PIN #1 OF RT-BGA ADAPTER

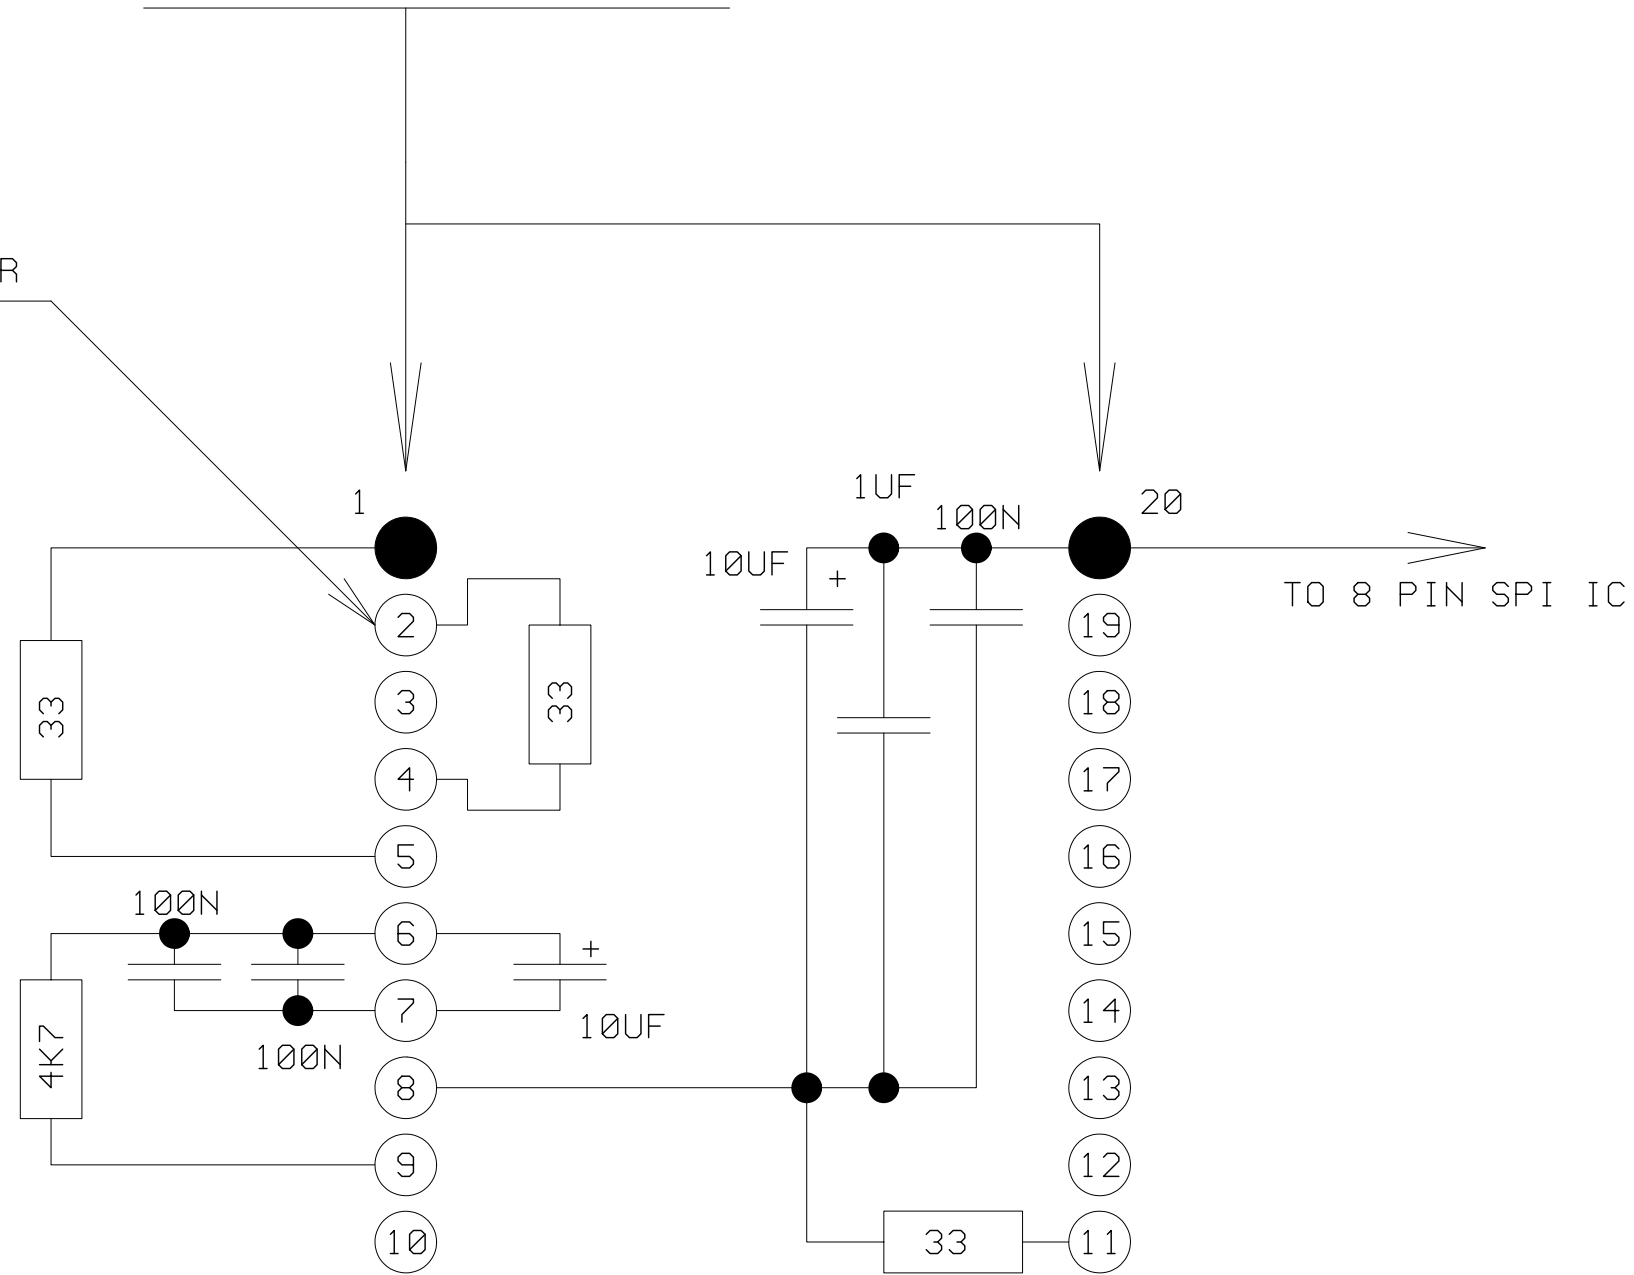
THESE PINS MUST BE ADDED!

PIN #5 MUST BE CUTTED FROM THE NODE OF RT-BGA ADAPTER!

NOTICE: ALL CERAMIC CAPACITORS MUST BE PLACED ON BOTTOM SIDE AS CLOSE AS POSSIBLE TO BGA ADAPTER AREA!

SPI FLASH MUST BE REMOVED
